Authorization to Proceed (ATP)

Valerie Spangler Landslide
High Priority
Abandoned Mine Land (AML) Reclamation Project
based on or Categorical Exclusion (CX)
Letcher County, Kentucky

State: KY PA: KY 4131 SGA
Project Name: Valerie Spangler Landslide HP AML Reclamation Project
Project Description: Stabilize the hillside behind the Valerie Spangler residence

Subject: Review of "Authorization to Proceed" (ATP) Request

ATP Review USFWS MOA Kentucky Watersheds & Indiana Bat

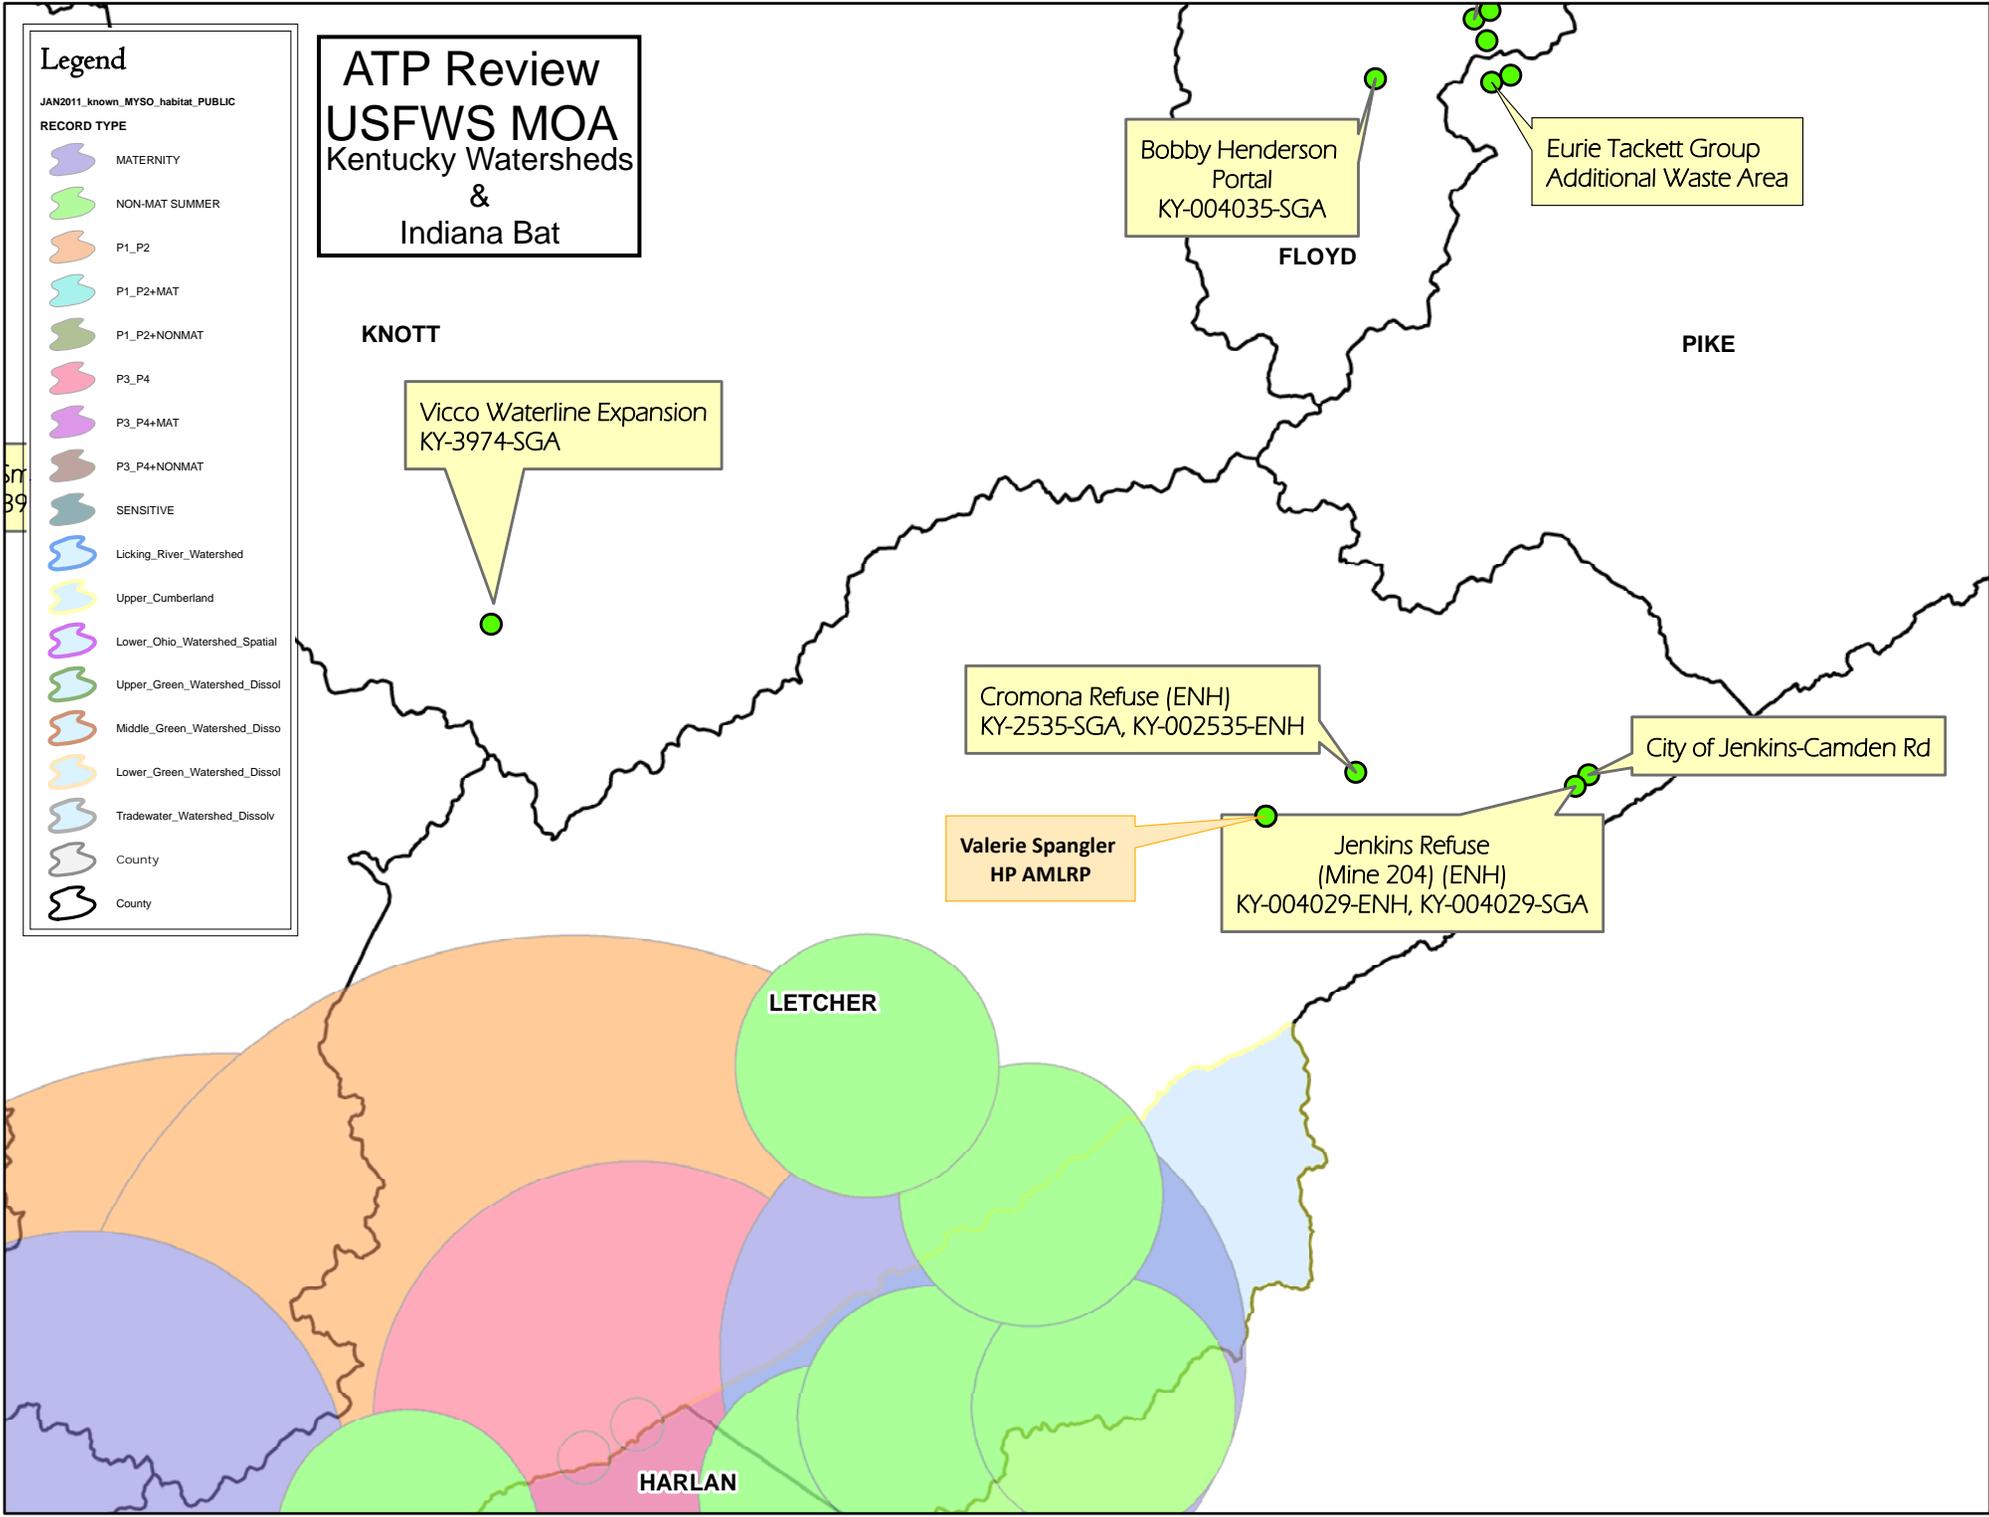
The concern with the Blackside dace is addressed by the watershed of concern for that species. The habitat for this species is in the Upper Cumberland watershed in southeastern Kentucky. This project is located east of the extent of the Upper Cumberland watershed; therefore, the threat to this species is minimal. The DAML Biologist also noted that the federally listed endangered Indiana bat, although not indicated to exist in the project vicinity; by his and the KDFWR reviews, would not be disturbed by the project. This is based on the fact that the project proposes to disturb no mine portals, cliffs, or caves, and proposes no disturbance of forested areas that could be utilized as roosting sites other than that area impacted by the AML problem that is creating a threat to the public.

- There will be no purposeful removal of standing trees larger than 5 inches diameter at breast height or standing snags with loose bark that are 9 inch or greater diameter at breast height and at least 10 feet in height, during the period of April 1 to October 14, and the proposed activity does not occur in "Known Indiana Bat Habitat".

- No caves or clifflines will be disturbed;
- The project proposes to reclaim no open mine portals/shafts.
- No purposeful filling or crossing of streams using heavy equipment or the removal of riparian vegetation using heavy equipment within the Tradewater, lower Ohio, Upper Cumberland, Green, and Licking River basins.

With the specifics of the proposal meeting the criteria set out in the MOA, OSM agrees with DAML's determination that the proposed project would not adversely impact the species if these conditions are present. With this information, they found the requirements of Section 7 of the Endangered Species Act have been fulfilled.
